# UNITED STATES PATENT AND TRADEMARK OFFICE

APPLICATION NO.	FILING DATE	FIRST NAMED INVENTOR	ATTORNEY DOCKET NO.	CONFIRMATION NO.
09/823,600	03/30/2001	David Chong Sook Lim	17732-3856000	6055

# Office Action Summary

*Attachment to Paper No. 18*

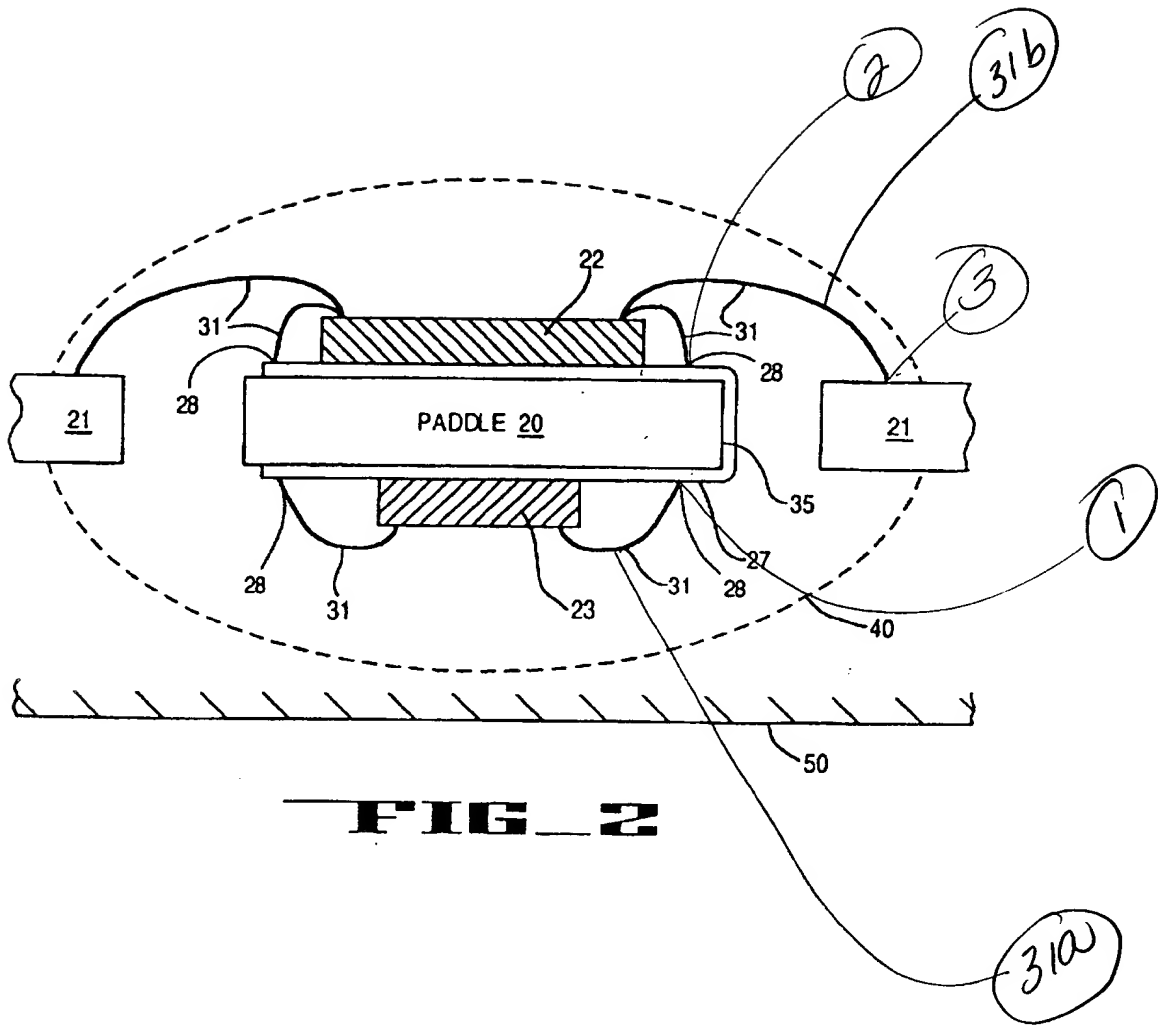
13. Regarding claim 18 (as understood), Kuhn (see attached figure 2) shows a package having a substrate (21, 20, 27) comprising a plurality of leads conductive leads (the wiring of the circuit 27) defining first contacts 1 which are arranged to accept electrical connections from the electrical contacts of a die down die 23. Also, Kuhn shows second contacts 2 which are arranged to correspond to a die up die 22.

14. Regarding claim 19 (as understood), Kuhn shows electrically conductive wires 31a joining electrical contacts of the die down die to the first contacts on the substrate. Also, Kuhn teaches that the substrate includes third contacts 3 which are arranged to

make electrical connection to the die up die 22, and electrical conductive wires 31b joining the second and the third contacts.

19. Regarding claim 32 (as understood), Kuhn (see attached figure 2) shows a package having a substrate (21, 20, 27) comprising a plurality of conductive leads (the wiring of the circuit 27) defining first contacts 1 which are arranged to accept electrical connection from the electrical contacts of a die down die 23, and second contacts 2 which are arranged to correspond to a die up die 22. Also, the Kuhn shows third contact leads 3, and electrical connections 31b connecting the third and second contacts.
